Duke Energy Corporation

Subject: McGuire Nuclear Station
Docket No. 50-369/50-370
Request for Additional Information
Related to Generic Letter 96-06

**NRC Request for Additional Information Related to Generic
Letter 96-06 for McGuire Nuclear Station, Units 1 & 2**

ATTACHMENT 5

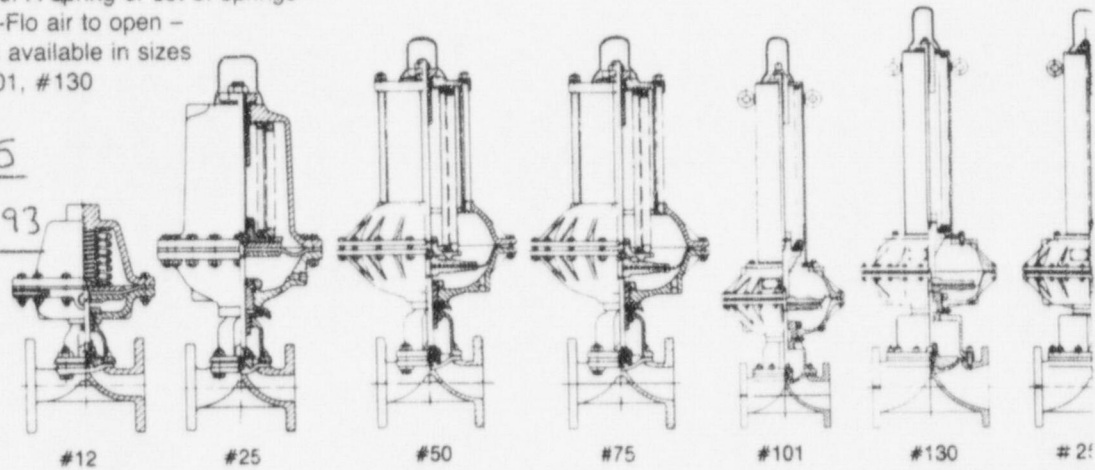
Item #2: McGuire's submittal of January 28, 1997 indicated that a total of five pipe segments are isolated by at least one soft seated diaphragm valve in each unit, and are susceptible to thermally induced pressurization. This submittal also stated that these soft seated valves are capable of slight leakage or displacement. For each of these pipe segments, provide a drawing of the valve. Identify the pressure at which the valve was determined to lift off its seat or leak and describe the method used to estimate this pressure. Discuss any sources of uncertainty associated with this estimated liftoff or leakage pressure.

The estimated leakage pressure for each valve was obtained by identifying the maximum live pressure at 100% pressure differential (P.D.) shown on vendor literature associated with the subject valves (reference Attachment 5). Assuming a 100% P.D. exists across each closed valve during Design Basis Conditions is conservative since a P.D. of less than 100% will result in upwards force on the respective valves diaphragm on both the downstream and upstream side of the valve. This would result in an upward force on a larger area

of the valve diaphragm and result in a lower estimated seat leakage pressure. Additional estimated leakage pressure uncertainty is associated with the allowed tolerances in each valve actuator's as-left spring compression. These tolerances could result in leakage pressures slightly above those shown in Attachment 1. However, these higher pressures will not result in valve seat leakage pressures that approach the maximum working pressure rating for the subject piping and valves. The maximum working pressure rating for the valves is > 250 psig as per ANSI B16.5-1968 and > 1100 psig for the piping as per Pipe Fabrication Institute Technical Bulletin TB1-1974.
